AGENDA

STAFF REPORT
KETCHUM PLANNING AND ZONING COMMISSION
SPECIAL MEETING ON SEPTEMBER 27, 2022

The City of Ketchum received a Preapplication Mountain Overlay Design Review application for the development of a new single family dwelling unit on July 21, 2022, referred to as the McGavick Residence. The proposed project is on a 6-acre vacant lot zoned Limited Residential (LR) located at 307 Garnet St on the south end of Ketchum in the Gem Streets Neighborhood (the “subject property”) as shown in Figure 1. The proposed residence has 18,756 square feet of living space which includes five bedrooms, 6 baths, three car garage, and attached pool house. Surrounding the dwelling unit is an extensive landscaping program that includes a garden, multiple hardscape patios and circulation paths, densely planted landscaped areas with trees and shrubs, open landscaped areas with low lying plants and flowers, and open turf and no-mow areas. The project plans, including architectural plans, site plan, landscape plans, and preliminary grading and drainage plans, are in Attachment B to this staff report.

**SITE GRADING +
DRAINAGE PLAN**

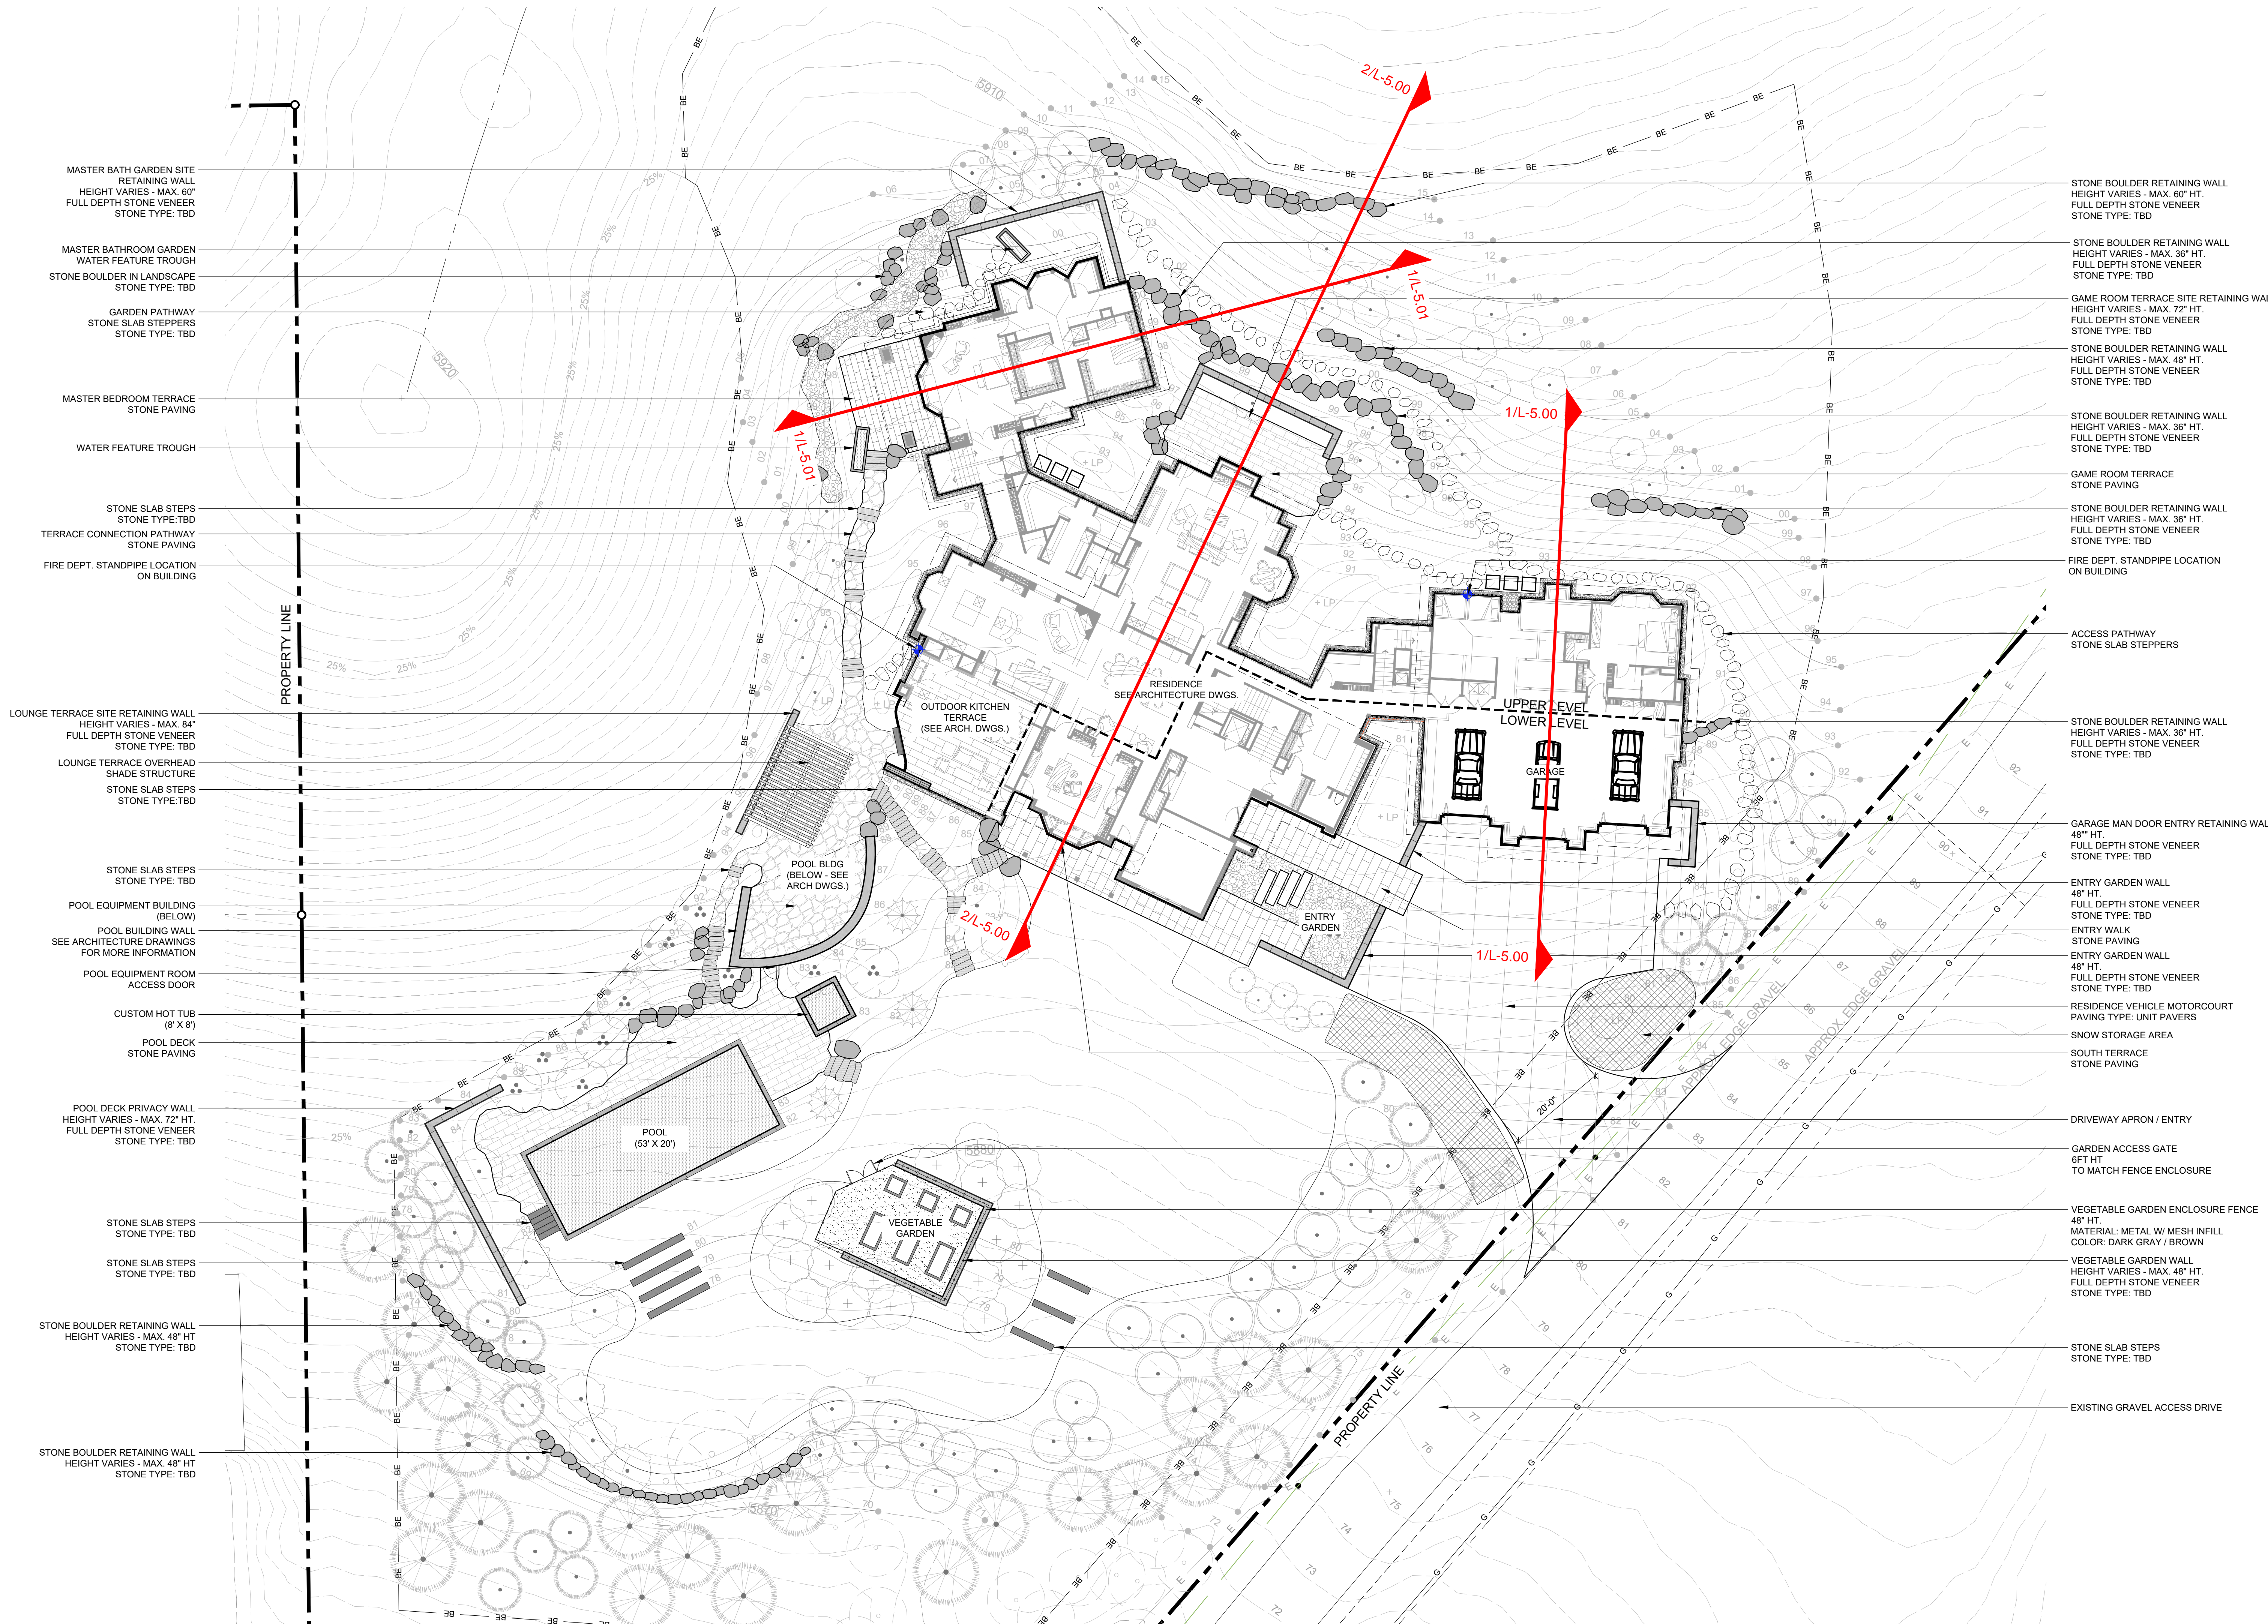
Pursuant to KMC §17.96.060.C1 and 17.124.170.A.1, all stormwater must be retained on site. The project plans include a grading and drainage plan; however, the proposed drainage funnels all stormwater along a newly created drainage swale along the private drive, south and off the property. This current configuration does not meet the city standards for retaining stormwater and will need to be addressed for the final design review application. The applicant is aware of this issue and will comply with the requirements as outlined in the KMC.

L-4.01

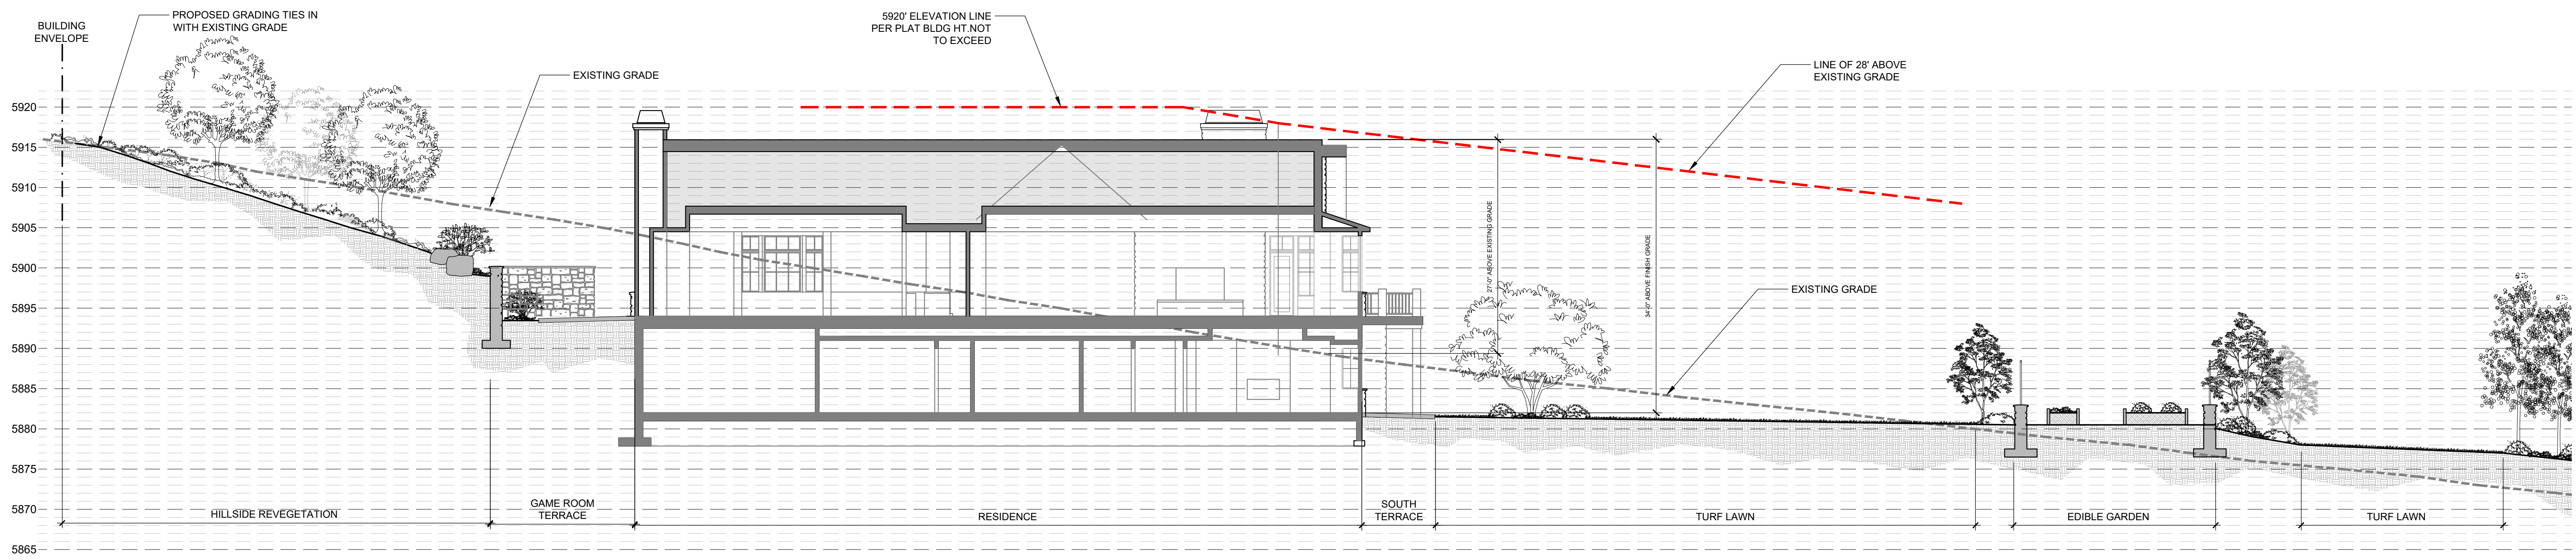
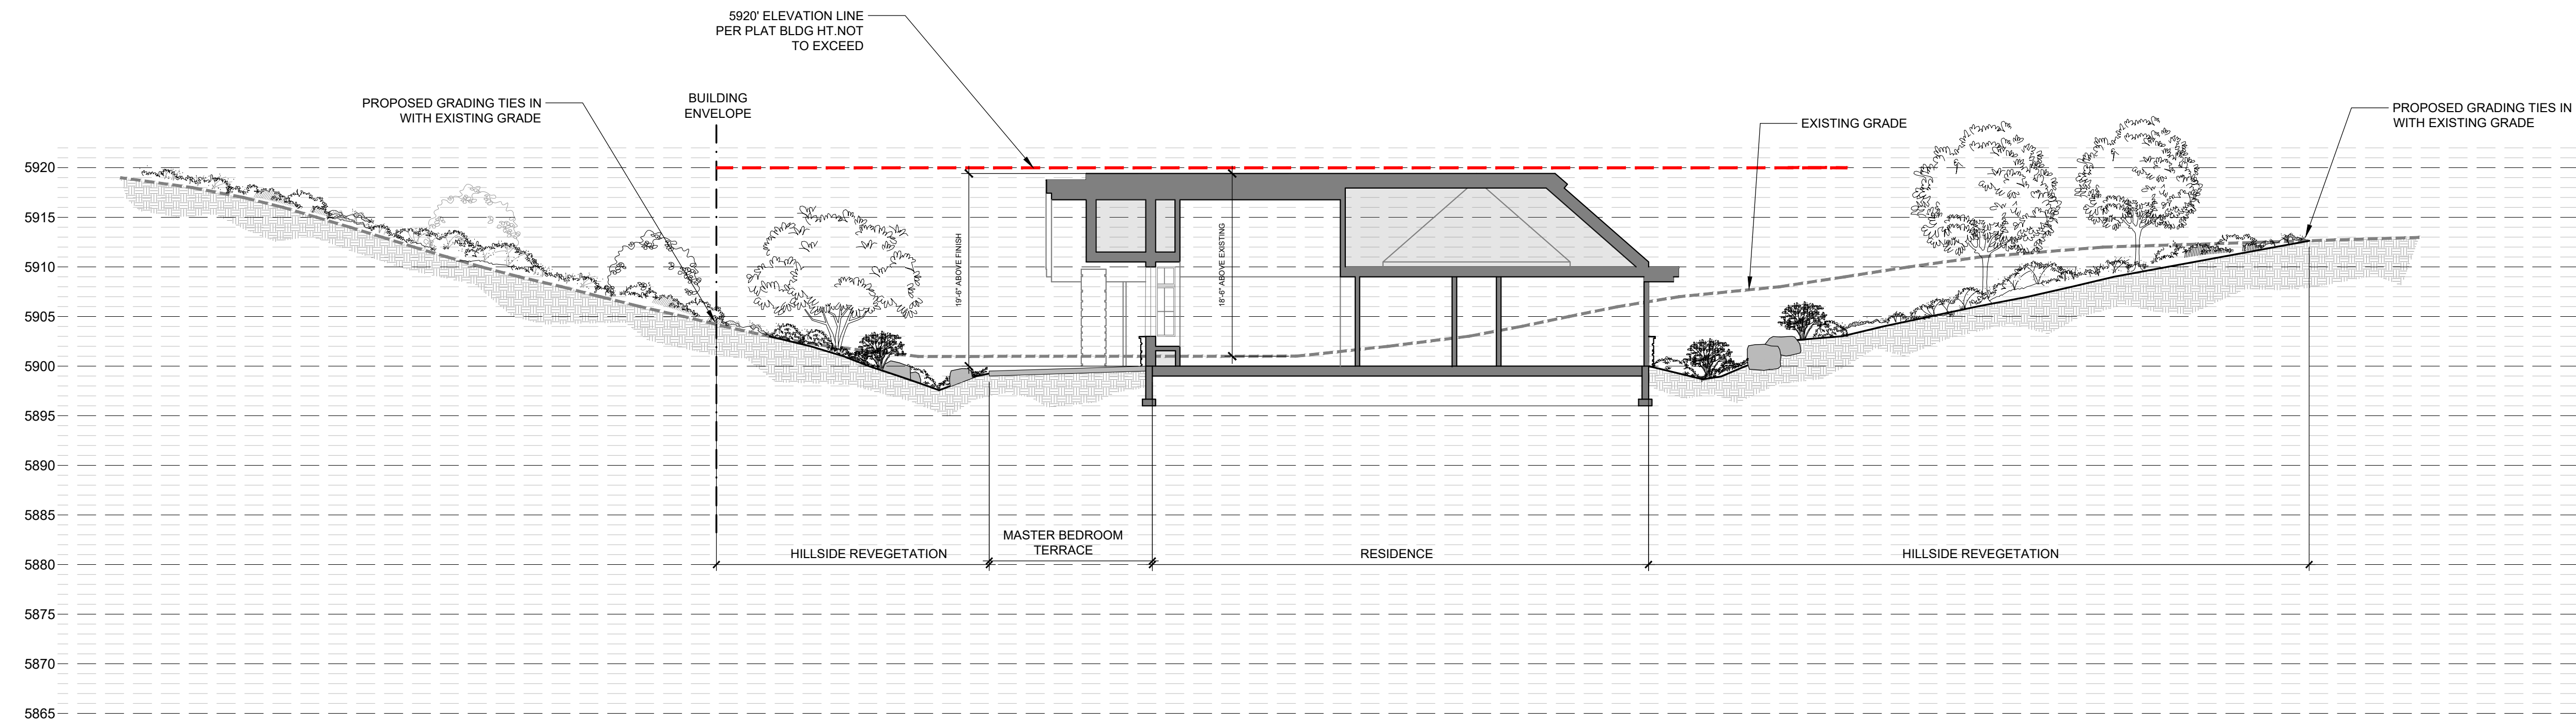
Sheets L4.01 through L5.01 show the locations of sections in plan view and section cuts for the building height calculations for the proposed project. The red line shows the elevation of 5920 on all three sections. As shown on Section 2, the red line shows not only the 5920 limitation but also the line of 28 feet above existing grade. Section 2 indicates the total building height from finished grade is 34 feet. Section 2 also shows the total building height does not exceed 28 feet above existing grade with the exception of the chimney, which is permitted as it does not exceed the elevation of 5920 feet.
